**Occurrence of Groundwater at the
Compact Waste Facility
Waste Control Specialists Facility
Andrews County, Texas**

George Rice

May 3, 2012

Figure 1
WCF Facility

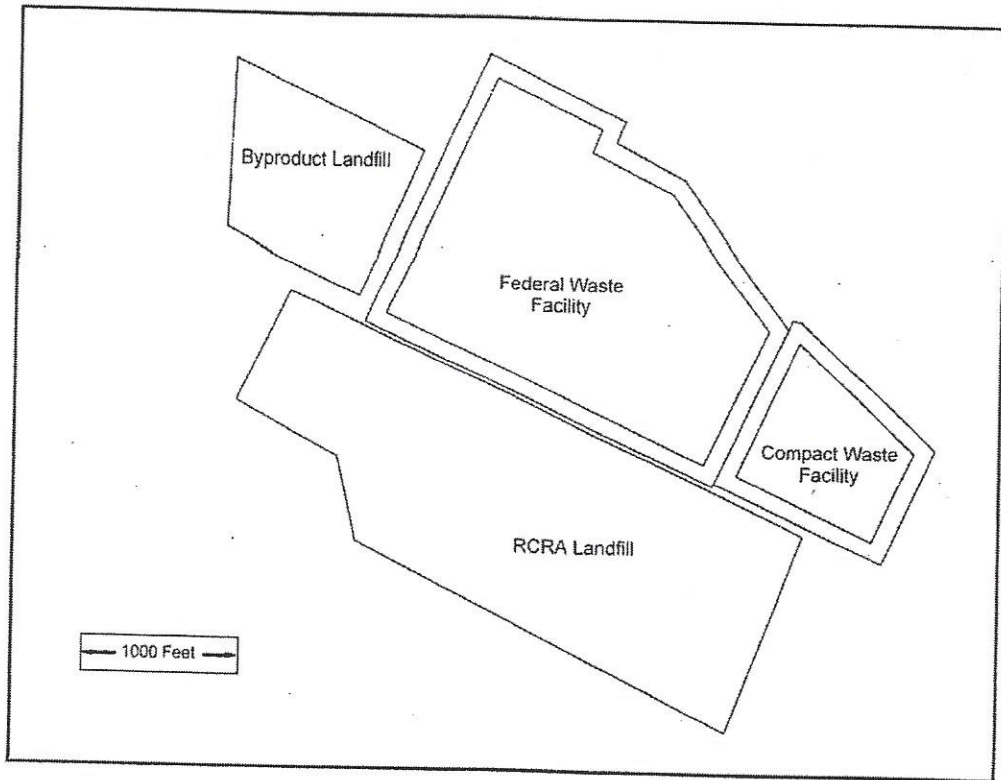
Groundwater (i.e., saturated conditions) exists in the buffer zone of the Compact Waste Facility (CWF) as well as in the CWF itself (figures 1 and 2). The groundwater occurs in two hydrologic units: the OAG unit¹ and the upper portion of the Dockum Group (aka red beds)² (figure 3). The OAG is the uppermost aquifer at the WCS facility³. Groundwater occurrence may be transient. That is, water levels fluctuate and a portion of the OAG or Dockum may be saturated at one time, and unsaturated at another⁴.
